**NUMBER:** 18-054-21 REV. A

Diesel Fuel Pump Failure and System Contamination

**NUMBER:** 18-060-20 REV. A

6.7L Cummins Engine High Pressure Fuel Injection Pump Identification Differences

**Fig. 2**  
**Fuel Lines With Isolators\*\***

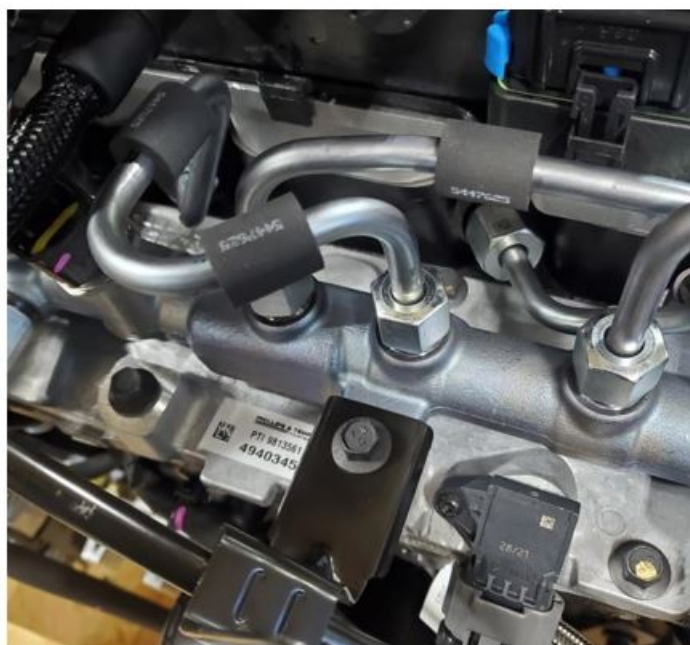
**NOTE: \*\*Ensure that the provided fuel line isolators (PN 68447788AA) are properly secured onto the #3 and #4 fuel rail to injector connector tube fuel lines as shown.**

**Fig. 3**  
**Remove Stud Location**

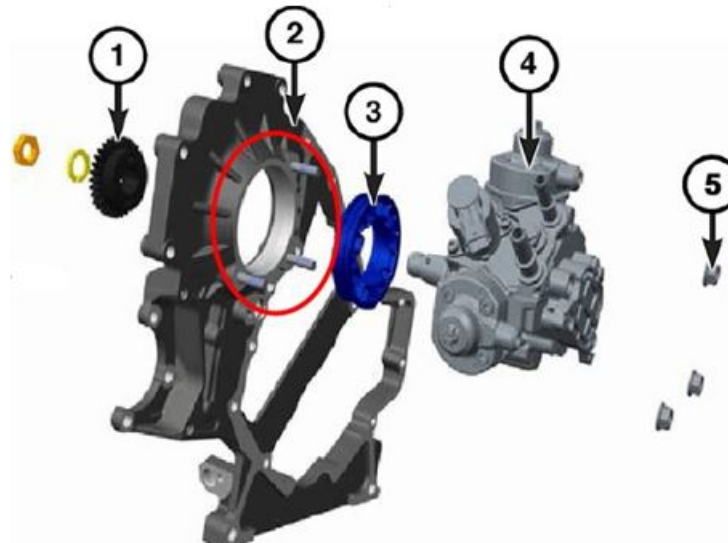
1. Remove the High Pressure Fuel Injection Pump. Refer to Service Library, Service Information Section 14-Fuel System > Fuel Delivery, Diesel > Pump, Fuel Injection > Removal.
2. Remove all three fuel pump mounting studs in the front gear housing and discard them (Fig. 3) .

**Fig. 4**  
**Fuel Pump Mounting Adapter Plate**

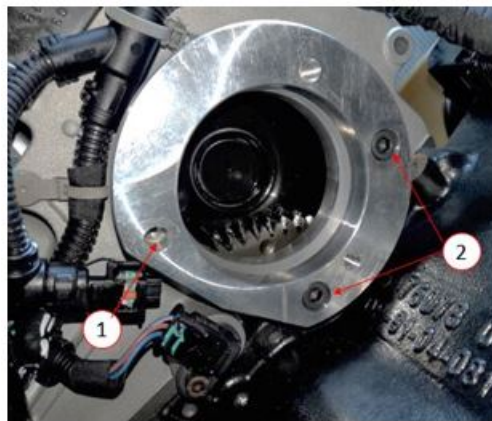
3. Use a M8 x 1.25 tap to clean out all three holes where the studs were removed.
4. Install the fuel pump adapter plate (PN 68573989AA) with the flattened side pointing down so there is clearance for the cam positioning sensor and counterbores facing the fuel pump.
5. Install both of the bolts (PN 68578596AA) 25mm M8 in the 2 bolts holes near the engine (Fig. 4) .

6. Loosely install bolt (PN 4429446) in location (1) (Fig. 4) to help properly align the adapter before torquing bolts (PN 68578596AA). Torque both bolts (PN 3420835) to 24 N·m (17.7 ft.lbs.).
7. Remove the loosely installed bolt in location (1) (Fig. 4) . This will be used in a later step.

**Fig. 5**  
**Pilot Adapter on Fuel Pump**

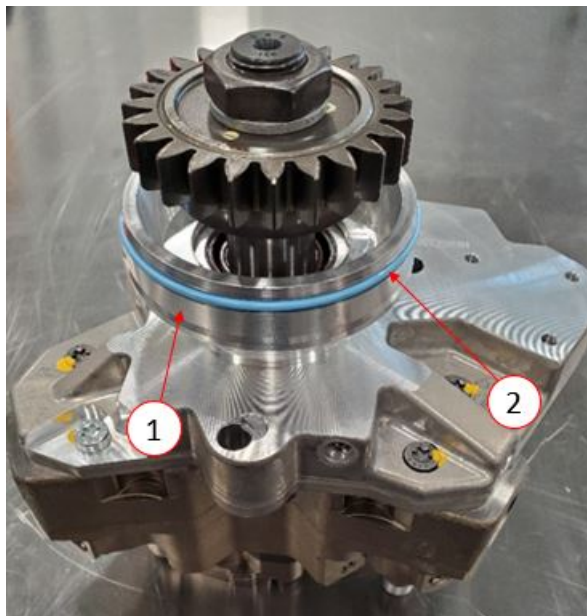
9. Lubricate **new** O-ring (PN 68444371AA) on the pump body with engine oil and then install the pilot adapter onto the pump body with the smaller diameter side towards the fuel pump (Fig. 5) .

**Fig. 6**  
**Supply and Return Fitting Location**

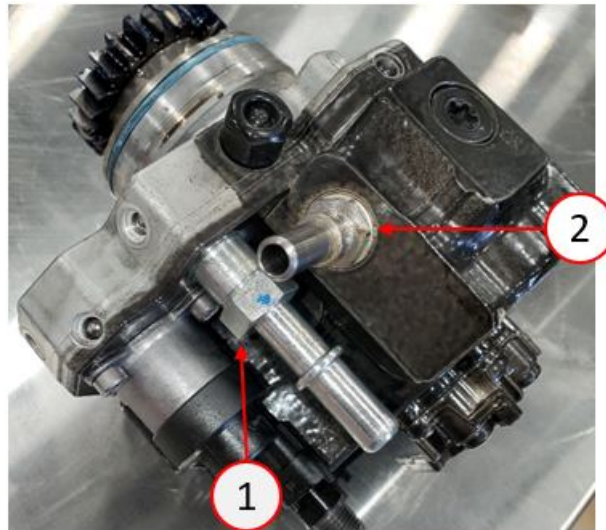
13. Install the supply and return quick disconnect fittings onto the pump as shown below and torque to 24 N·m (17.7 ft lbs) (Fig. 6) .

**Fig. 7**  
**Fuel Pump Shaft**

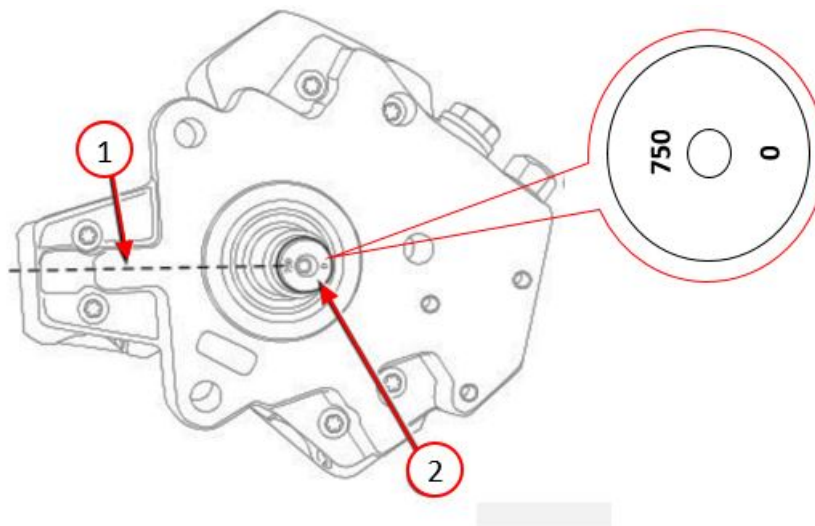
14. **Fuel Injection Pump Phasing:** Perform the following phasing procedure anytime the injection pump has been removed and reinstalled.
15. Make sure engine cylinder 1 is at Top Dead Center (TDC) position.
16. Locate the end of the fuel injection pump shaft . Two numbers (750 or 754 and 0) are stamped into the end of the shaft.
17. Rotate the injection pump shaft until the number 5 (located in the center of number 750 or 754) is positioned at 9 o'clock (Fig. 7) .

**Fig. 8**  
**Fuel Pump Faster Location**

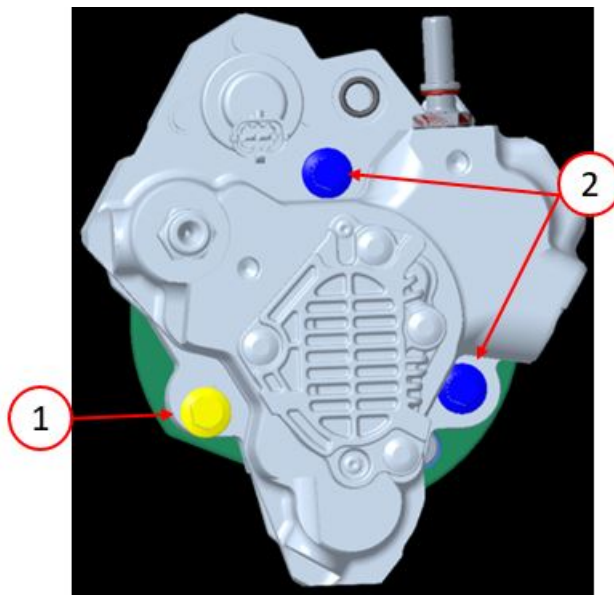
18. Position the injection pump to mounting flange on gear housing while aligning injection pump shaft through back of injection pump gear. Be sure the number 5 is still at the 9 o'clock position.
19. Before installing the pump use a clean rag, wipe the back side of the camshaft gear to remove residual oil. It is only necessary to wipe the portion of the camshaft gear which is accessible through the fuel pump bore in the gear housing.
20. The pump will need to be rotated to fit correctly in the space claim.
21. Install the long 60 mm cap screw (PN 4429446). (Fig. 8) first loosely (yellow bolt in picture below).
22. Then install the two shorter 40 mm cap screws (PN 4638665) (Fig. 8) (blue bolt in picture below).

Fig. 9

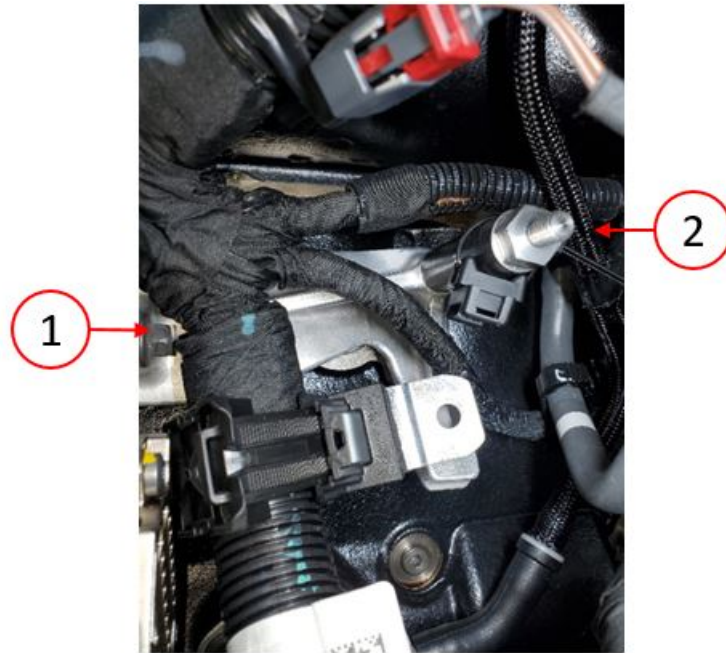
26. Install the fuel pump tail support bracket to fuel pump. Loosely install the tail support bracket on the fuel pump using bolt (PN 4429114) 30mm M8 (Fig. 9) .

Fig. 10

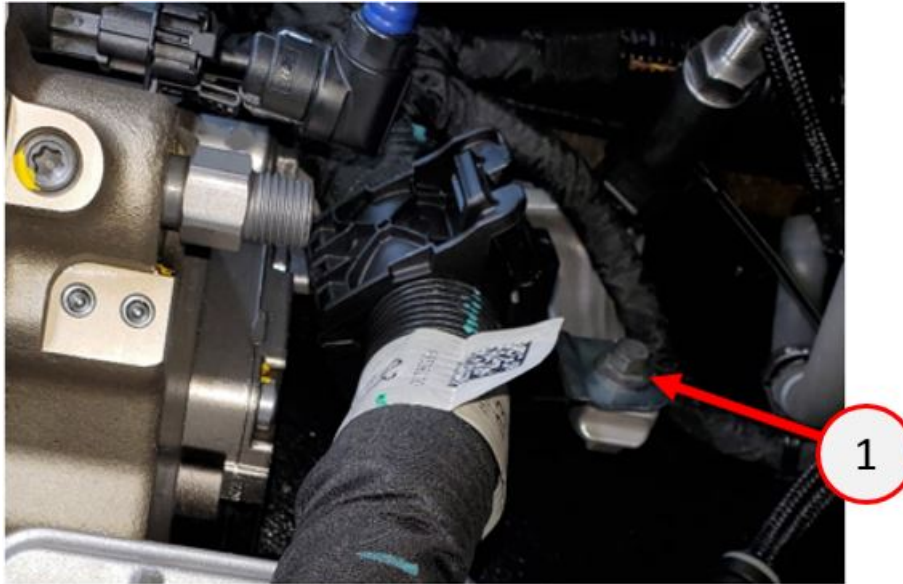
27. Loosely install the fuel line standoff to block through the tail support (68573994AA).  
28. Torque both ends of the fuel pump tail support to 24 N·m (17.7 ft.lbs.).  
29. The tie down bracket **must** be loosened so it can be rotated and positioned to be secured to the leg of the fuel pump tail support to ensure there is no twisting of the main engine harness. The tie down bracket can be loosened by inserting a small flat head screwdriver into a slot in the tie down (Fig. 10) .

**Fig. 11**  
**Main Engine Harness Tie down Bracket**

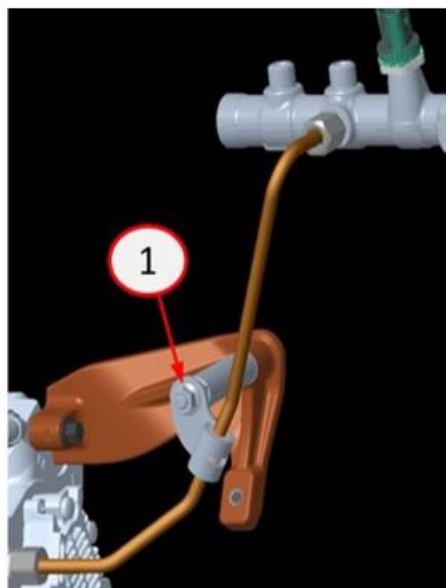
30. With the tie down bracket still loose around the main engine harness, secure the tie down bracket to the tail of the fuel pump tail support using bolt (PN 4429630) and torque bolt to 10 N·m (7.3 ft.lbs.). Tighten the tie down bracket around the main engine harness using the zip closure (Fig. 11) .

**Fig. 13**  
**New ECM Mounting Bracket and Faster Location**

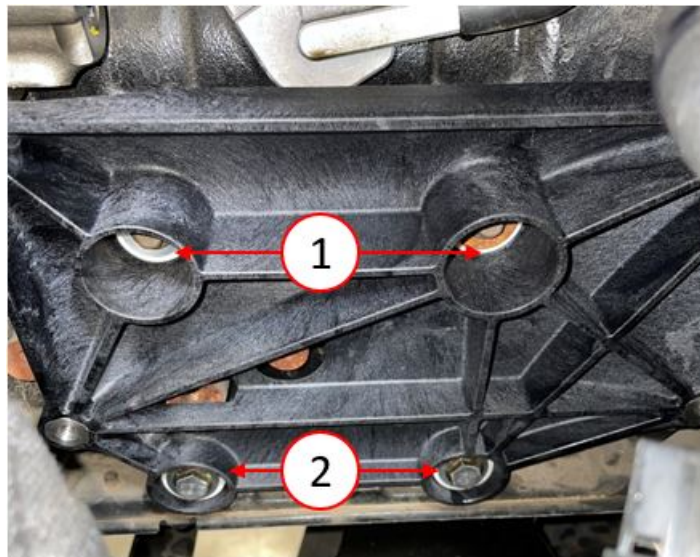
36. The second supply port in the rail will need to be blocked off using rail block off nut (PN 68573999AA) and torque to 55 N·m (40.5 ft.lbs.).
37. Install the new ECM mounting bracket using the same top bolts that came out of the original mounting bracket install them in the new mounting bracket and torque to 24 N·m (17.7 ft.lbs.).
38. Using the provided bottom bolts (PN 68578595AA) install them into the new mounting bracket and torque to 24 N·m (17.7 ft.lbs.) (Fig. 13) .

**Fig. 14**  
**Location of Tie down on Quantity Solenoid**

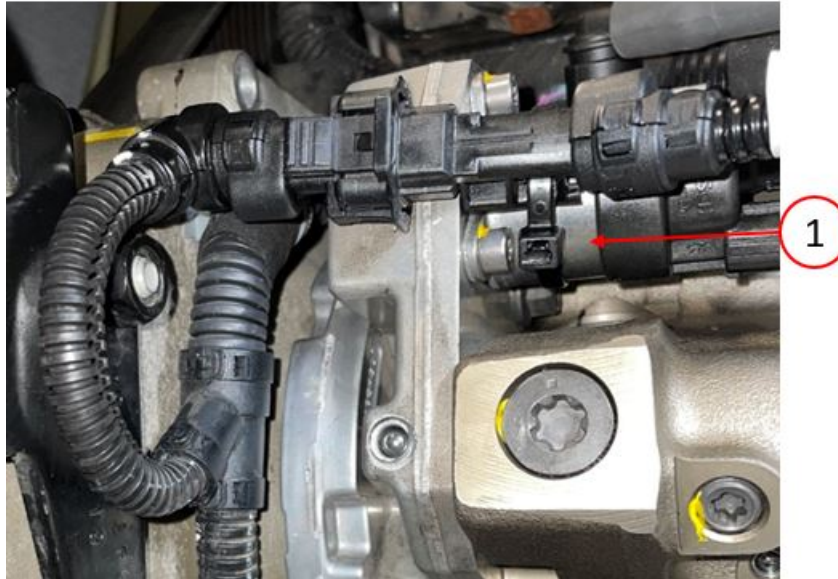
- 48. Install and connect Engine Wiring Harness Jumper (PN 68573991AA) to Fuel Quantity Solenoid. Connect the female side of the jumper harness to the engine wiring harness that originally attached to the Fuel Quantity Solenoid (Fig. 14) .

**Fig. 15**  
**Tie Down Location Swivel Bracket Tie Down Location**

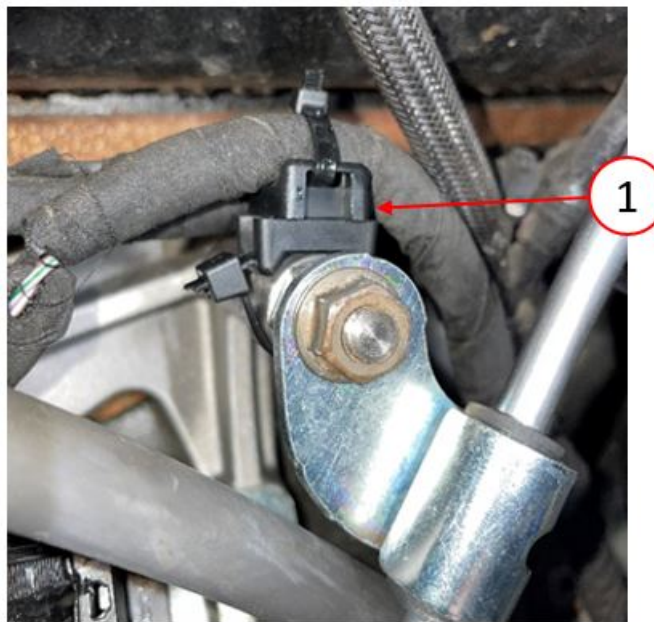
- 49. Connect the male side of the jumper to the Fuel Quantity Solenoid on the fuel pump.
- 50. Tie down the jumper using the provided zip-tie (PN 68038172AA) (1) as shown in the picture below.
- 51. Using the provided zip-ties (PN 68038172AA) attach the swivel bracket to the fuel line standoff and secure the wire harness pig tail to the swivel bracket (Fig. 15) .

Fig. 2

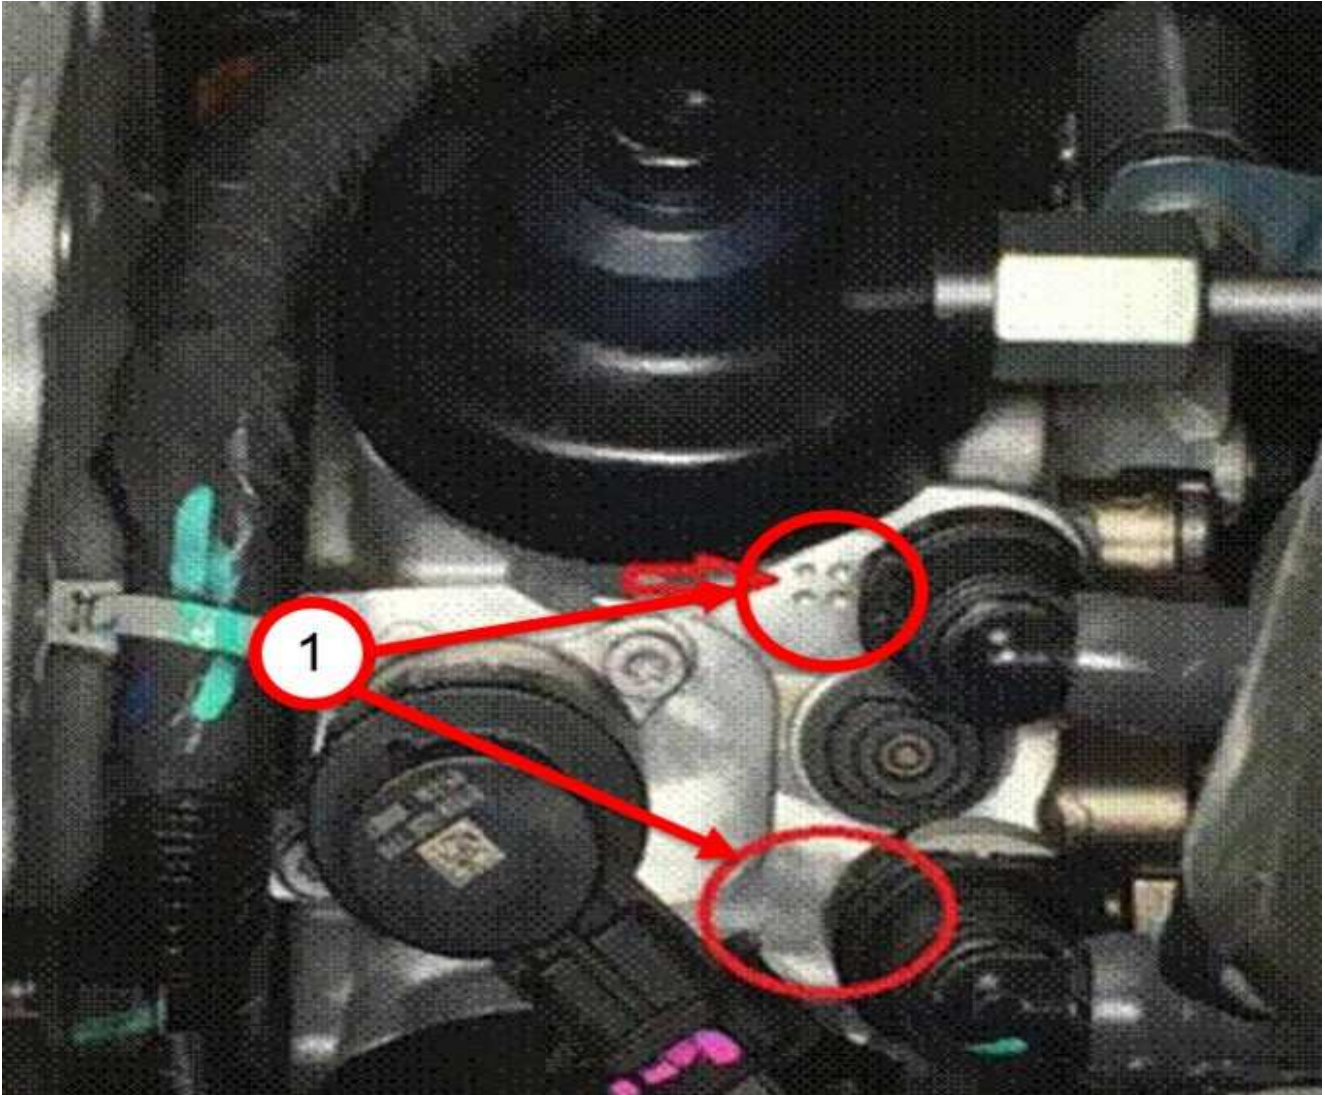
- Vehicles with the old syle Asymmetrical Cam design will have either multiple dots or no dots embossed in the pump housing (Fig. 2) .
- Vehicles with an Asymmetrical Cam pump, choose the calibration labeled Asymetric Cam or Asym Cam.
